INDESIT company

Model type:
BAAN12

Commercial code:
F034674

N1030093fig1

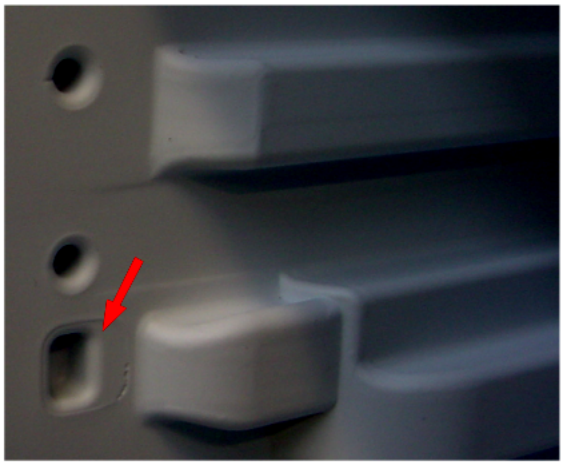
n1030093: New fixing of evaporator on static fridge-freezers (05 range) 60 cm,Melano

From August 05 (serial no. 50802.0001) the freezer evaporator is secured to the cabinet by a plastic profile.
The cabinet walls have been modified to create locations to house the profile, which is installed on the front of each evaporator plate (see photo N1030093fig1- fig2 - fig3)
The profile cannot be fitted on premodification appliances, so technical personnel must continue to fit the rh and lh supports on these models (see photo N1030093fig4)

New parts
C00141135 = WHITE PROFILE L=443.5 MM

Parts replaced
C00075596 = EVAPORATOR RH SUPPORT
C00075597 = EVAPORATOR LH SUPPORT

N1030093fig1

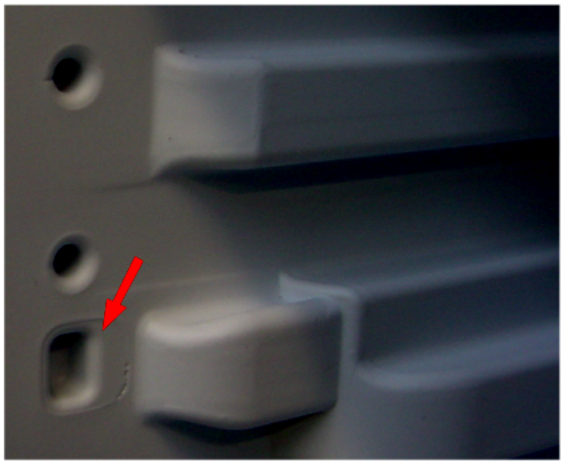
n1030094: New fixing of evaporator on static fridge-freezers (05 range) 60 cm, Lodowek

From August 05 (serial no. 50820.0001) the freezer evaporator is secured to the cabinet by a plastic profile.
The cabinet walls have been modified to create locations to house the profile, which is installed on the front of each evaporator

plate (see photo N1030093fig1- fig2 - fig3)
The profile cannot be fitted on premodification appliances, so technical personnel must continue to fit the rh and lh supports on these models (see photo N1030093fig4)

New parts
C00141135 = WHITE PROFILE L=443.5 MM

Parts replaced
C00075596 = EVAPORATOR RH SUPPORT
C00075597 = EVAPORATOR LH SUPPORT
